Subject: Response to TCA comments on PWA watershed analysis

Subject: Foothill Transportation Corridor-South Runoff Management Plan Supplemental Documentation Review and Comment

Subject: Refined I-5 Widening (AIP-R) Runoff Management Plan: Response to TCA's comments on Coastal Commission Staff Report, Foothill Transportation Corridor-South

Figure ES-2. Enlargement Curve for Southern California.

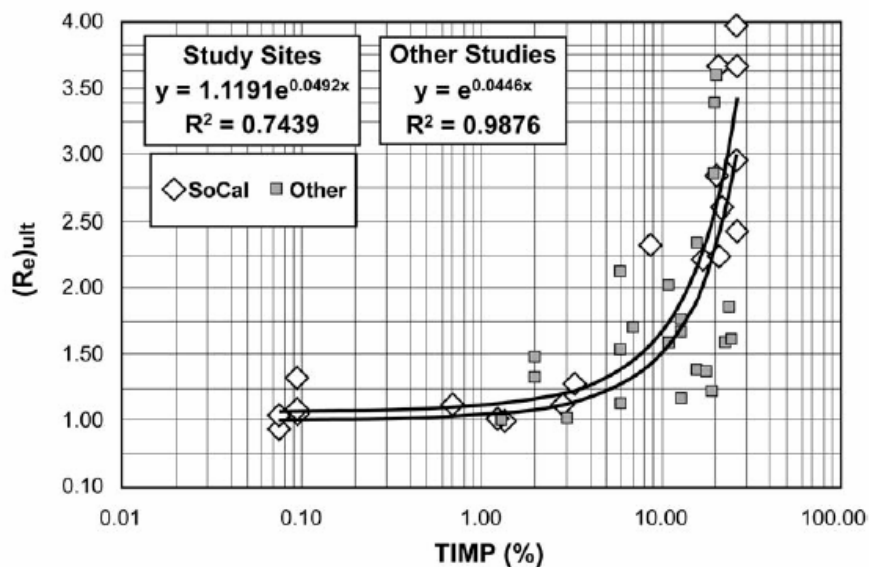
Assessing channel erosion impacts at the point where the proposed project discharges into a receiving water body gives a more accurate measurement of the true scale of project impacts on headwaters tributaries and watersheds. This is especially important in headwaters areas since while these areas constitute a relatively small portion of the total watershed *area* for San Mateo Creek, they are the source of most of the eroded *sediment*, the other areas being dominated by sediment transport or deposition. Simply looking at the percentage of the total watershed impacted by impervious area ignores these localized but highly significant stream impacts. Studies in California and elsewhere have shown that the erosion impact to a stream channel is exponentially proportional to percentage of the upstream watershed that is impermeable (see figure below).

The figure above (source: Coleman and others, 2005) shows the percentage of a watershed that is impermeable upstream of a point along a channel (TIMP) versus the ratio of channel enlargement through erosion that results (Re). As can be seen, increases in the area of the upstream watershed that is impermeable of between 5-10% cause channels to erode until they have enlarged their volume by 25-50%, with increases in impermeable area between 10 and 20% causing channel sizes to double or more. This process of channel enlargement generates large volumes of sediment that is transported downstream to the main river channel and ultimately to the river mouth.
